ANSTY GARDEN COMMUNITY,

DESIGNERS RESPONSE

REPORT REF NO. 2207280-R15B

- 1.4 The Audit was undertaken on the proposed A272 Southern Access roundabout junction, which is located to the south of the proposed development site. The works involve the construction of a new roundabout and pedestrian/cycle infrastructure improvements to include new crossing facilities.

Drawing Number: **2207280-005** Rev **E**

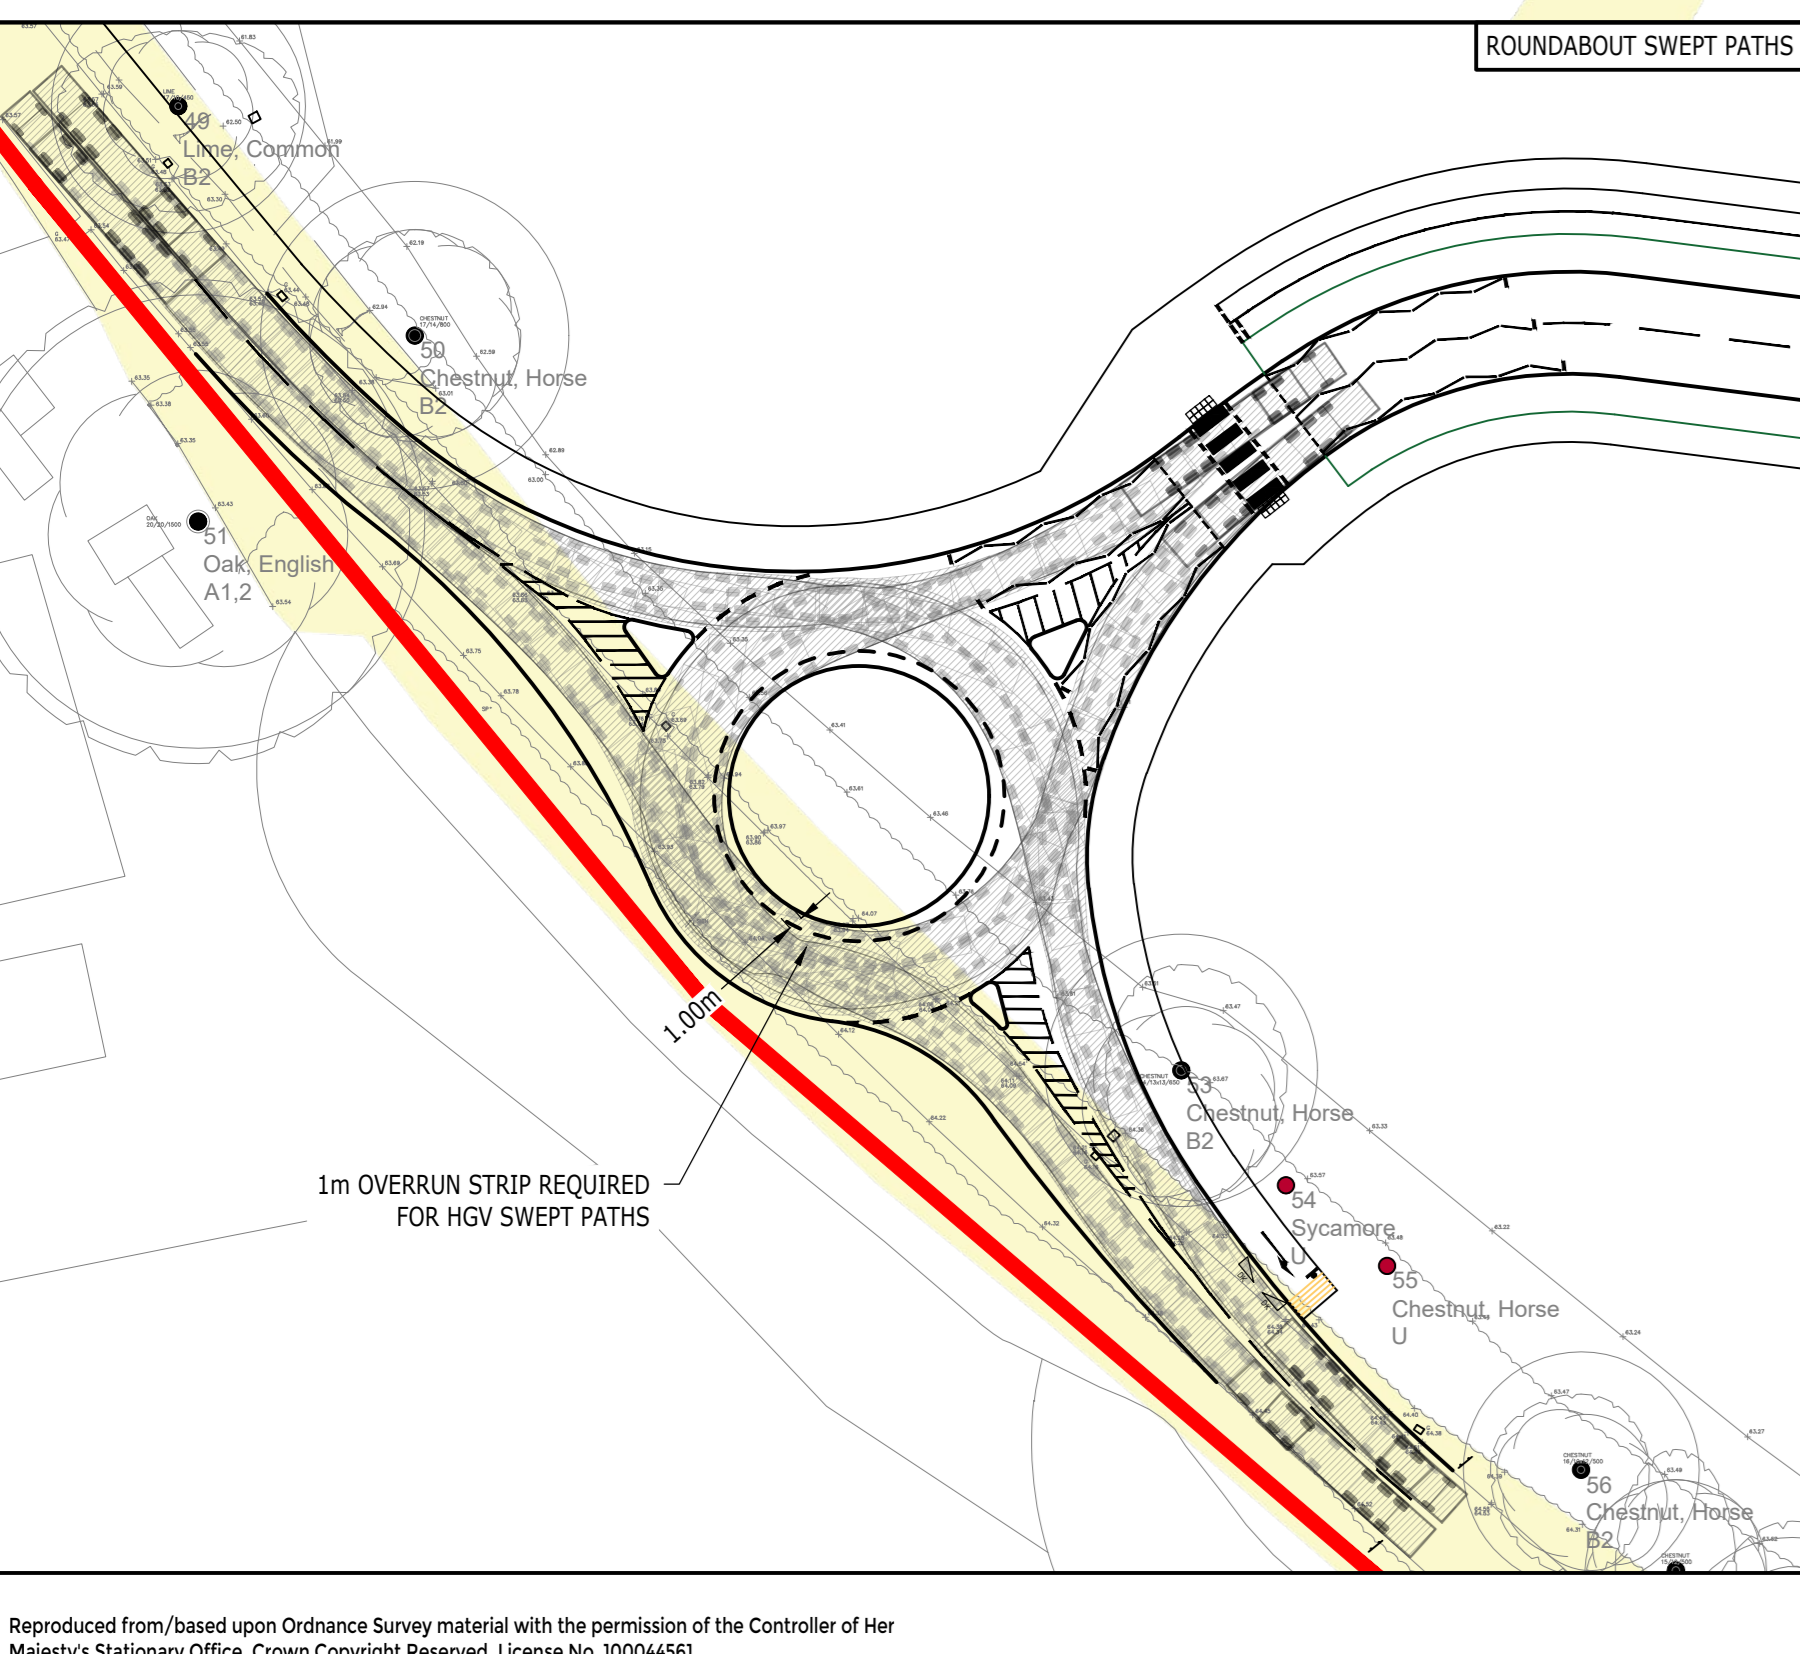
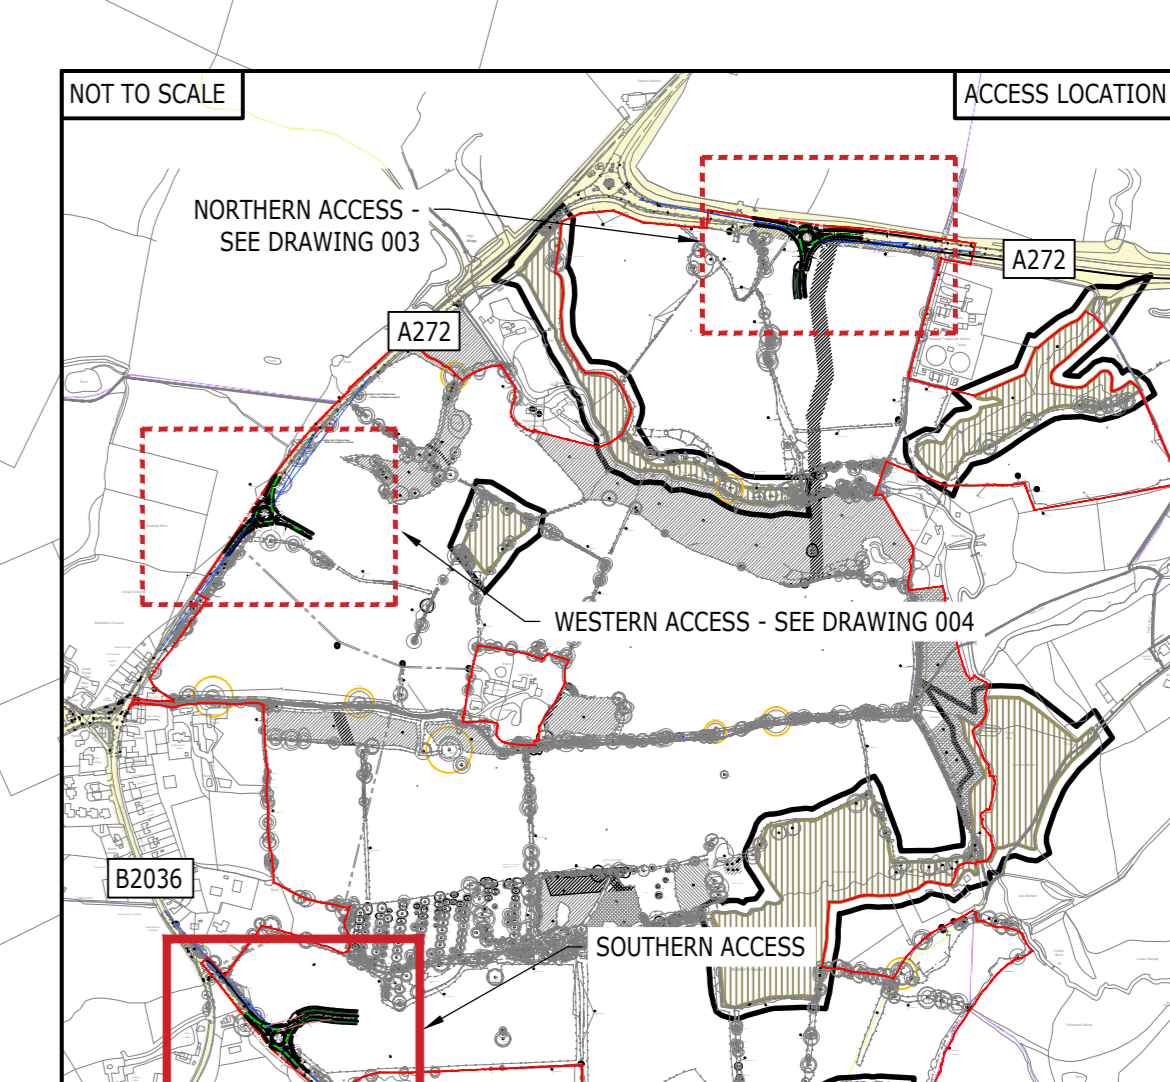
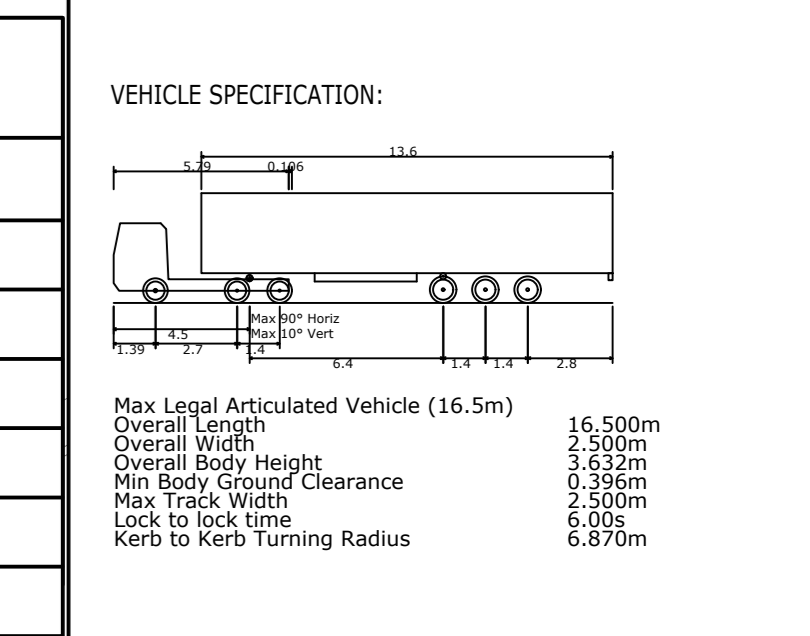
RSA problem	RSA recommendation	Design Organisation response	Overseeing Organisation response	Agreed RSA action
<p>3.1.1 Insufficient construction details could lead to overshoot or rear end shunt collisions.</p> <p>The proposals do not include the introduction of anti-skid surfacing or detail the Polished Stone Value (PSV) to be used on the approaches to the roundabout and surfacing as part of the scheme. Surfacing with an insufficient PSV could lead to overshoot or rear end shunt collisions.</p>	<p>It is recommended that high friction surfacing should be provided on all the approaches to the roundabout and that the PSV of all surfacing should be provided for assessment.</p>	<p>Agree. Details of PSV values and surfacing materials will be provided for Stage 2 Audit.</p>	<p>High friction surfacing should be provided and details of PSV values to be provided at detailed design stage.</p>	<p>High friction surfacing will be provided and details of PSV values to be provided at detailed design stage.</p>

<p>3.1.2 Ponding of surface water could lead to loss of control collisions.</p> <p>Kerblines are being amended as part of these proposals, where no details of</p>	<p>It is recommended that drainage details should be provided at Stage 2 Safety Audit.</p>	<p>Agree. Drainage details will be provided for Stage 2 Audit.</p>	<p>Drainage details to be provided at detailed design.</p>	<p>Drainage details to be provided at detailed design.</p>

<p>3.1.4 Inappropriate surfacing could lead to vehicle to pedestrian / cyclist collisions or rear end shunts.</p> <p>The proposals do not include the introduction of anti-skid surfacing or a surface with a high polished stone value on the approaches to the Parallel crossing. Surfacing with an inadequate PSV could lead to vehicles not being able to stop, leading to possible rear end shunt or vehicle to pedestrian / cyclist collisions.</p>	<p>It is recommended that antiskid surfacing or surfacing with a high PSV should be used on the approaches to the crossing.</p>	<p>Agree. Details of PSV values and surfacing materials will be provided for Stage 2 Audit</p>	<p>High friction surfacing should be provided and details of PSV values to be provided at detailed design stage.</p>	<p>High friction surfacing will be provided and details of PSV values to be provided at detailed design stage.</p>
<p>3.2.1 Approaches to the proposed roundabout.</p> <p>Stopping Sight Distances (SSD) have been provided for assessment and at 215m are acceptable for the current national speed limit. An insufficient SSD may increase the risk of junction related or shunt type collisions at the roundabout and so the 120m SSD, which is commensurate with a 40mph design speed, should only be incorporated if a reduced speed limit of 40mph is introduced.</p>	<p>It is recommended that the SSD should be commensurate with the design speeds.</p>	<p>Agree. The proposed roundabout will significantly change the nature of speeds approaching the proposed crossing location, resulting in lower than compared to the current speeds</p> <p>Visibility splays for the current posted speed has been shown and noted to be kept clear to be robust at this stage.</p> <p>A change in speed limit is at the discretion of WSCC but agreed, if there is a change, the splays provided will be in accordance with speed limit.</p>	<p>Visibility splays to be provided in line with future posted speed limit.</p>	<p>Visibility splays to be provided in line with future posted speed limit.</p>

<p>3.2.3 Lack of vertical profile information could lead to side impact collisions and loss of control collisions.</p> <p>The proposed roundabout is located on Harvest Hill, where there is a fall from the northwest to the southeast. At this early stage no vertical alignment details were</p>	It is recommended that vertical alignment details should be provided for assessment at Stage 2 Safety Audit.	Agree. Details of vertical alignments will be provided for Stage 2 Audit.	Vertical alignments to be provided at detailed design.	Vertical alignments to be provided at detailed design.

<p>3.3.1 Insufficient capacity could lead to rear end shunt or side impact collisions.</p> <p>No details of expected flows and the capacity of the roundabout have been provided for assessment.</p>	<p>It is recommended that the roundabout should operate without excessive queuing and with balanced flows and that an ARCADY or similar model should be provided for assessment..</p>	<p>Agree. An ARCADY assessment has been undertaken and demonstrates that the junction operates with spare capacity in the Development Case scenario. The results are attached at Appendix C.</p>	<p>Junction Modelling has been provided and indicates the junction would work within capacity in a 2039 future year scenario.</p>	<p>No further action at this stage.</p>

<p>3.5.2 Insufficient road markings could lead to vehicle to pedestrian / cyclist collisions.</p> <p>At this early-stage full details of road markings have not been provided for assessment, including the Controlled Area. A lack of a Controlled Area could lead to inappropriate parking near the crossing that may restrict intervisibility, increasing the risk of vehicle to pedestrian / cyclist collisions.</p>	<p>It is recommended that the Controlled Area should be provided for assessment at Stage 2 Safety Audit.</p>	<p>Agree. The proposed parallel crossing has been updated on ACE Drawing 2207280-005E with appropriate road markings as per TSRGD standards. Further details will be provided at Stage 2 Safety Audit.</p>	<p>Road markings have been included within the drawing and will be included within the stage 2 Audit.</p>	<p>All necessary road markings to be included for RSA2.</p>
--	--	---	---	---

- 1.6 The following drawing have been prepared to incorporate the findings of the RSA:
- **ACE Drawing 2207280-005E** – Proposed Roundabout Southern Access (A272)

As presented on ACE Drawing 2207280-005E , the design incorporates suitable visibility splays based on the current posted speed limit.		
<p>3.2.2 Insufficient Stopping Sight Distance may increase the risk of junction related or shunt type collisions at the roundabout.</p> <p>On the westbound approach to the roundabout no SSD has been provided for assessment. There is concern that the SSD could pass over non-highway land. Vegetation or landscaping features in this splay could restrict visibility, where insufficient visibility may increase the risk of junction related or shunt type collisions at the roundabout.</p>	It is recommended that the SSD should be supplied for assessment and that they should be within the adoptable highway, or that a suitable covenant should be arranged to ensure that the splay is not affected by planting or landscaping features.	Agree. All visibility splays are within highway land or land within the development site and therefore can be kept clear as shown and noted on ACE Drawing 2207280-005E .	All visibility splays to be provided in highway land or within land under the applicants control.	No further action at this stage.
